19LC-033 STAFF REPORT

ADDRESS:
 1327 Ball/ Avenue H

REQUEST:
 The applicant is requesting a Certificate of Appropriateness in order rebuild the existing stairs and add new vertical balustrades.

Typical City-approved historic rail design

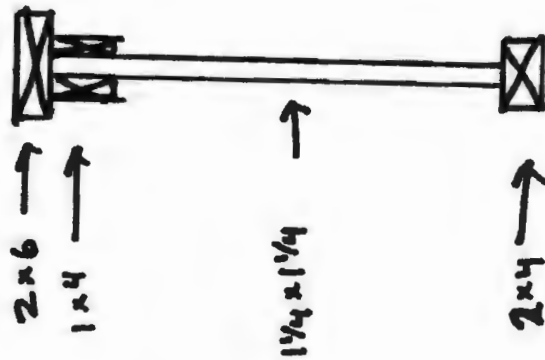
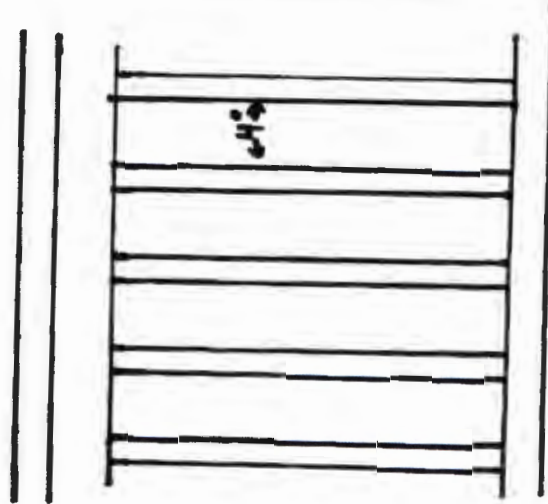
The new landing and stairs are located in Location B: Highly visible secondary wall: Preservation and repair in place is the priority. According to a Sanborn Map dated 1899 the stairs are not original to the house. Since the stairs are not original to the structure, Staff finds the railing should be in a simple square design with the balusters set inside the railing. Please see Exhibit E for the standard railing design for use in historic districts.

1. The work shall conform to the design, materials, and placement shown in Exhibit C of the Staff Report, with the following modifications:
 - a. The stairs shall be painted to match the house;
 - b. The railing shall be modified to match the design shown in Exhibit E within

Spacing between pickets is 4 inches on center. Gap from bottom of lower 2x4 rail to deck should be 3 inches.
